S E R V I C E N O T E

Agilent E5060A B-H/Z Analyzer

Serial Numbers: JP1KC00101 / JP1KC00123

Figure 1. AC Line Connector

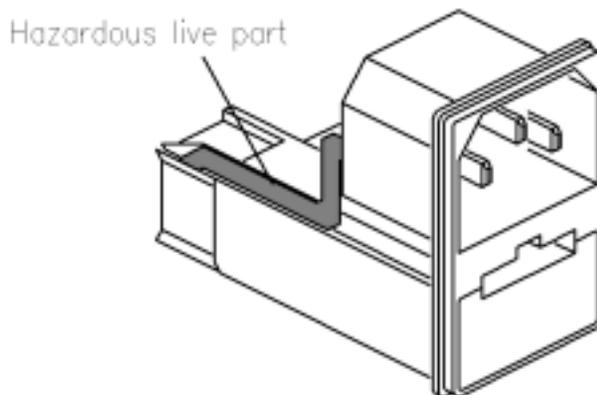
The AC inlet (P/N 1252-6951) has the potential to slip out of the instrument's rear panel slot if the AC power cord is forcefully pulled in a diagonal direction. When this happens, an exposed connection on the AC inlet module may touch the rear panel of the instrument and cause an electrical short if the AC power cord is still connected to the AC power outlet. See Figure 1.

In the worst case, there is also a possibility of an electric shock hazard to the user if the user completes a circuit between the instrument panel and another grounded connection while the AC power cord is still connected to the AC power outlet.

Solution 1. AC Inlet Still Intact.

- Remove the AC power cable from the AC power outlet and the product.
- Remove the top, bottom, and side covers.
- Seal the hot line terminal on the AC inlet with silicon paste (P/N 5183-4112).
- Reinforce the connection between the AC inlet and the rear panel with silicon paste.
- Perform Self Test to verify instrument operation.

Solution 2. AC Inlet Broken

- Remove the AC power cable from the AC power outlet and the product.
- Remove the top, bottom, and side covers.
- Seal the hot line terminal on the new AC inlet with silicon paste (P/N 5183-4112).
- Replace the AC Inlet (P/N 1252-6951).
- Reinforce the connection between the AC Inlet and the rear panel with silicon paste.
- Perform Self Test to verify instrument operation.

Figure 2. Repair Completed Label

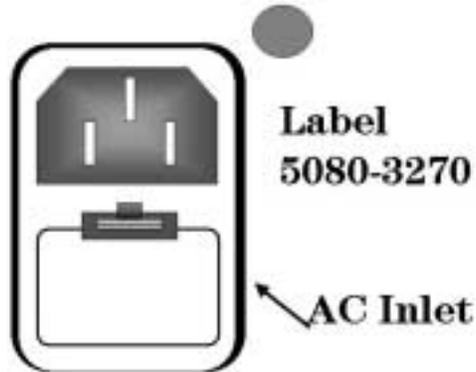
After completing the above instructions, stick the label (P/N 5080-3270) next to the AC Inlet on the rear panel as a mark that this repair has been completed. See Figure 2.

After completing the above instructions, stick the label (P/N 5080-3270) next to the AC Inlet on the rear panel as a mark that this repair has been completed. See Figure 2.
